Tables from the National Electrical Safety Code

Correction Sheet
September 29, 1989

***Tentative Interim Amendment 90-1
and
Second Correction Sheet***

**Tentative Interim Amendment 90-1
to the
National Electrical Safety Code
ANSI C2-1990**

**Fig 250-1
General Loading Map of United States with Respect
to Loading of Overhead Lines**

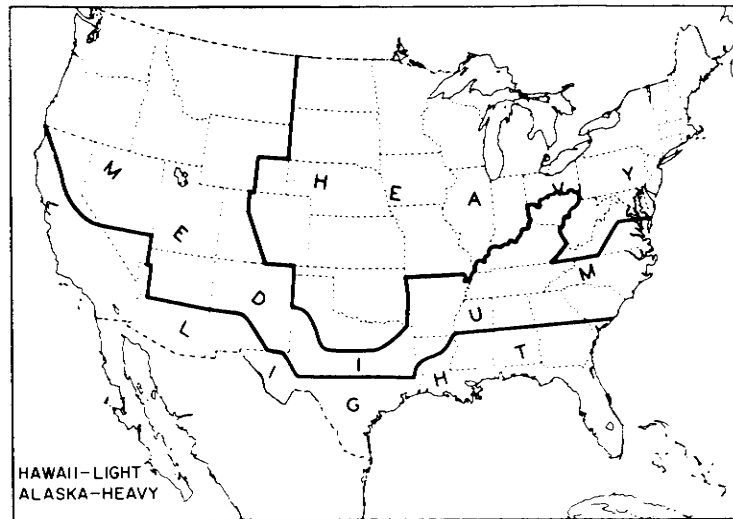
Fig 250-1 is missing only from the Second Printing. See Fig 250-1 on page 3 of this correction sheet.
